Technical Note

Migrating to PLX82-MNET-61850 Series B

Document Code: TN01-1-PLX8x-MNET-61850-0719

Date: July 2nd, 2019

Below are the dimensions for the PLX82-MNET-61850 **Series B** module for reference:

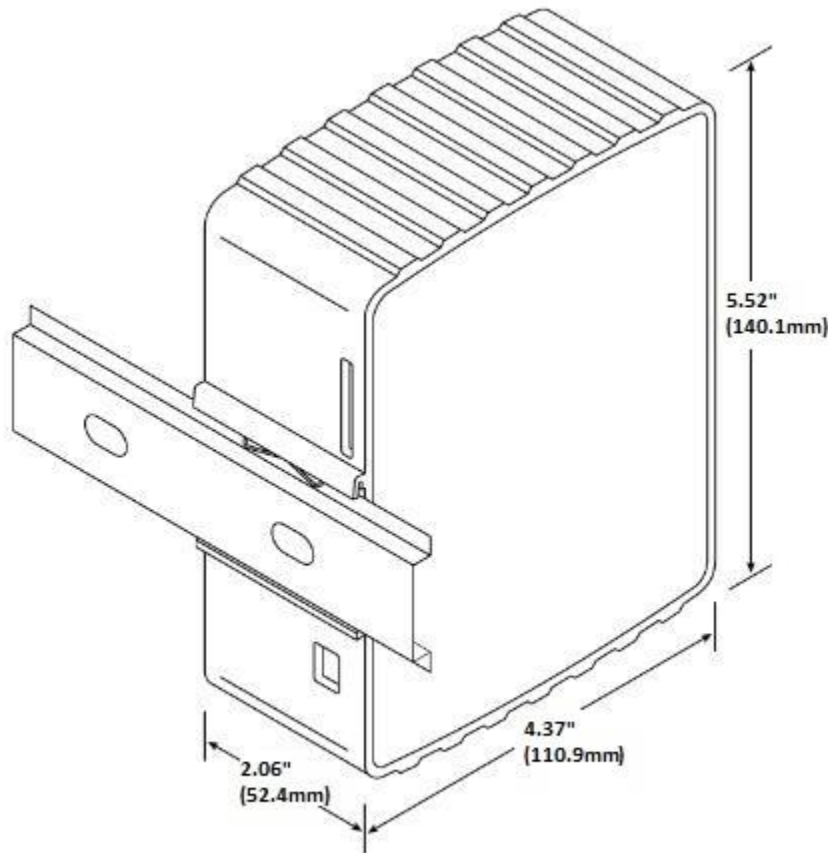
The differences between the Series A and PLX82-MNET-61850 Series B modules are minor, but something to take note of when replacing older Series A units with a PLX82-MNET-61850 Series B module. Below is a list:

1) *Temperature Range* – The PLX82-MNET-61850 Series B has a wider temperature range of 0°C to 70°C (32°F to 158°F). PLX81-MNET-61850 and PLX82-MNET-61850 Series A modules only had a temperature range of 0°C to 60°C (32°F to 140°F).
2) *Input Power* – The PLX82-MNET-61850 Series B module supports input power of 10-36 VDC. The PLX81-MNET-61850 and PLX82-MNET-61850 Series A had an input power range of 10-32 VDC.
3) *Module Enclosure Size* – When replacing Series A modules with Series B units, the enclosure size is larger on the Series B units, so if installing in an existing panel you will need to verify that there is sufficient room in the panel for the larger module enclosure, especially if replacing a PLX81-MNET-61850 unit with a PLX82-MNET-61850 Series B unit.

As shown above, when replacing either of the End-Of-Life PLX8x-MNET-61850 modules with a new **PLX82-MNET-61850** Series B module, the enclosure size is slightly larger (especially when converting from a PLX81 to a PLX82 due to the ¾" Width increase).

Please take into account the larger size of the new **PLX82-MNET-61850** Series B module.
